Re: Response to the Reference Number: **CC:**
8821, Confirmation Number: EA94135

Fcc ID: N79 CNT-800D

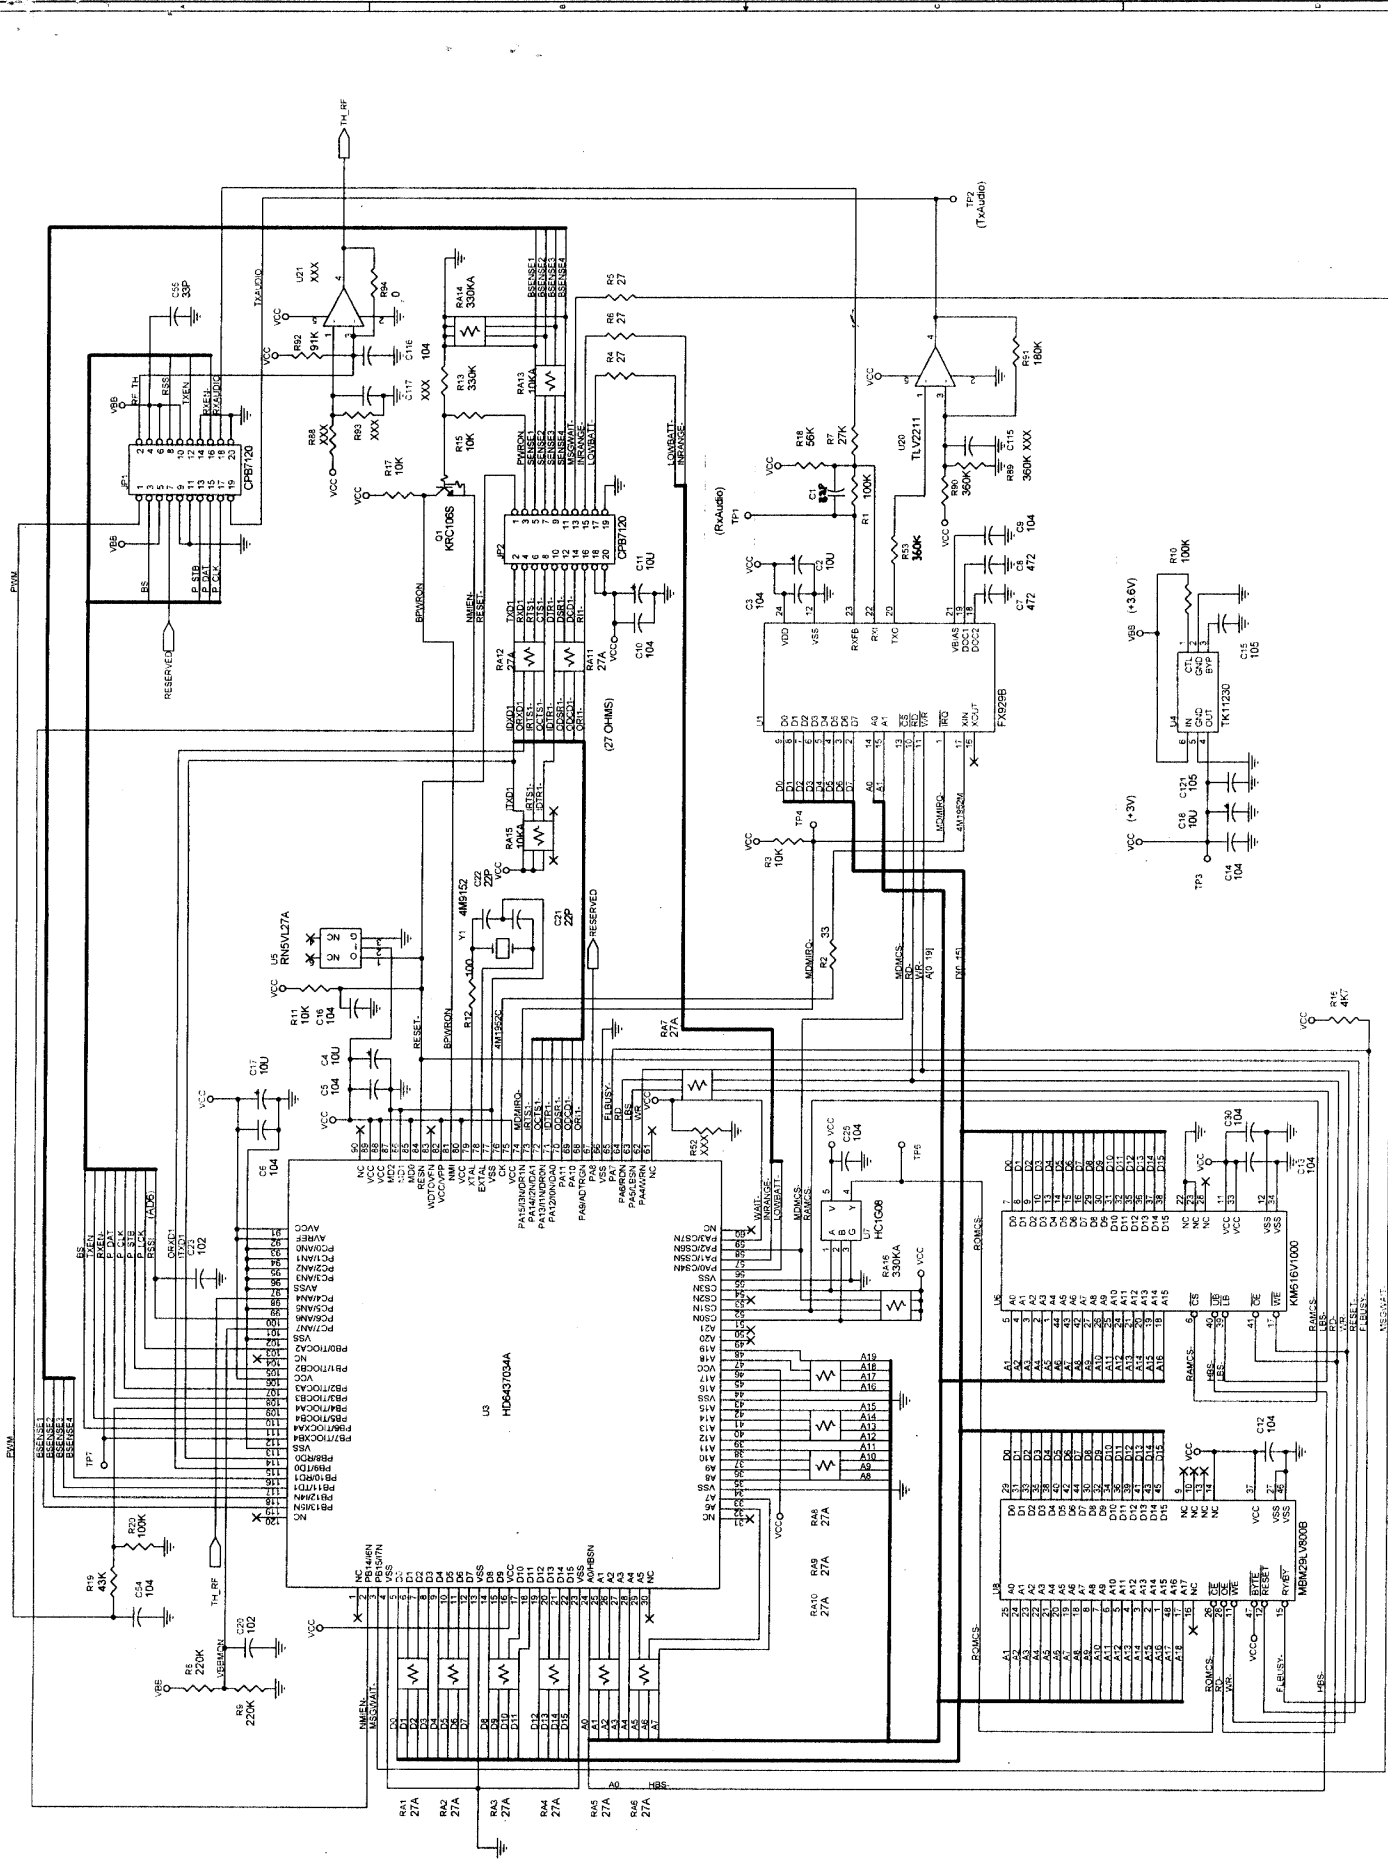
Thank you for the e-mail. I will like to response to the question as following:

- 1) We will provide the SAR data later.
- 2) Please see the attached page for the schematics.
- 3) The output power we got from the testing was EIRP. The ERP will be $124.8 \text{ dBuV/m} - 97.4 = 27.4 \text{ dBm} = 550 \text{ mW}$. Please make a change.
